PLUG AND ABANDONMENT PROCEDURE

Gallegos Canyon Unit #519

San Juan County, New Mexico / API 30-045-29057

CONDITIONS OF APPROVAL

Proposed P&A

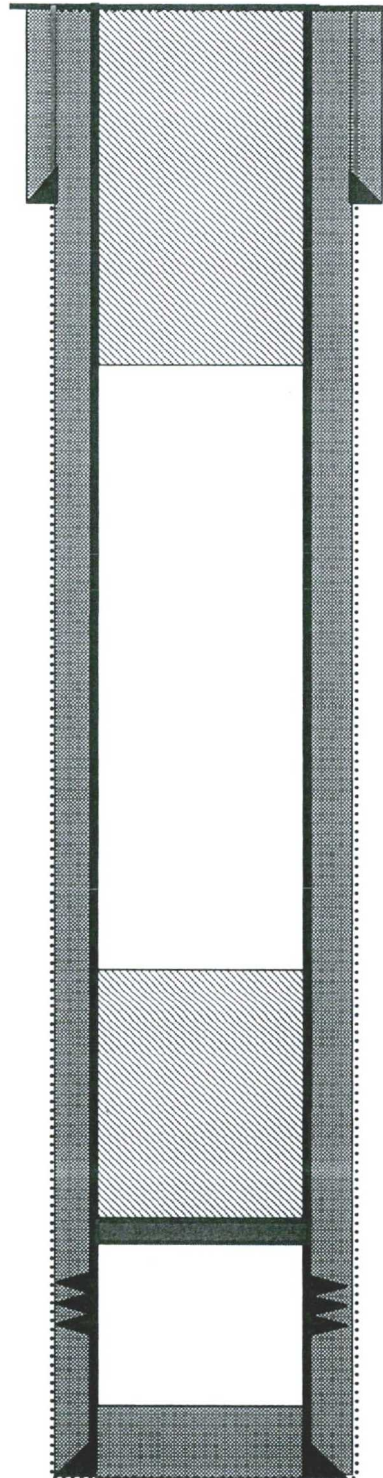
- a) Set Plug 1 (1302 – 963) ft. to cover the Fruitland top. BLM picks top of Fruitland at 1013 ft.
